SERVICE BULLETIN

M-1383A

2014 TRIKE AND CVO SOFTAIL HYDRAULIC CLUTCH - SAFETY RECALL 0160

Figure 1. Recall Kit 91500069

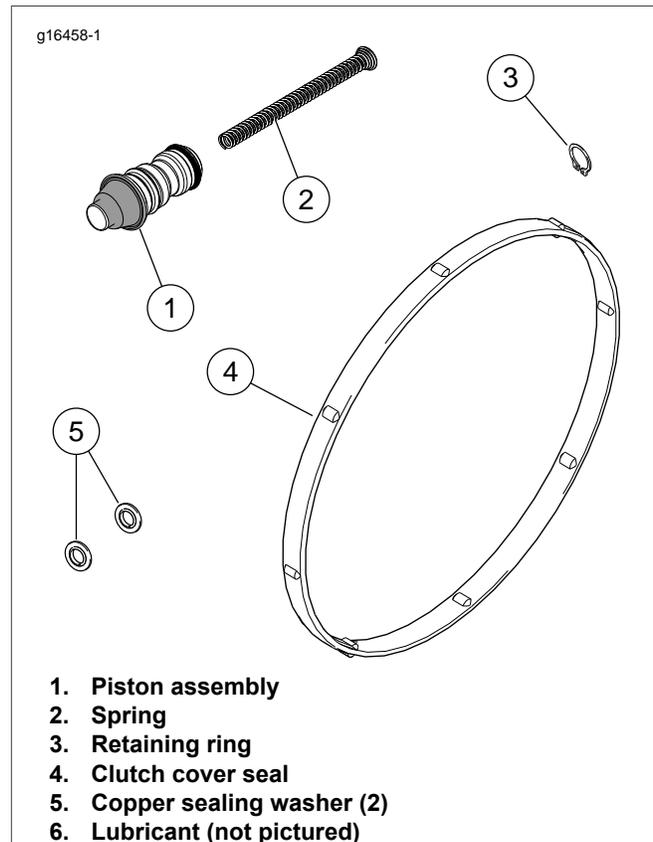
1. Confirm that the motorcycle is involved in Recall 0160.
2. Obtain the recall kit (Part No. 91500069).
3. Replace the clutch master cylinder piston assembly with parts from the recall kit. This kit is to be used on both original equipment clutch master cylinders and chrome accessory clutch master cylinders (Part No. 41700263 and 41700263A). See CLUTCH MASTER CYLINDER AND RESERVOIR in the service manual.
4. Fill and bleed clutch fluid system. See the service manual.
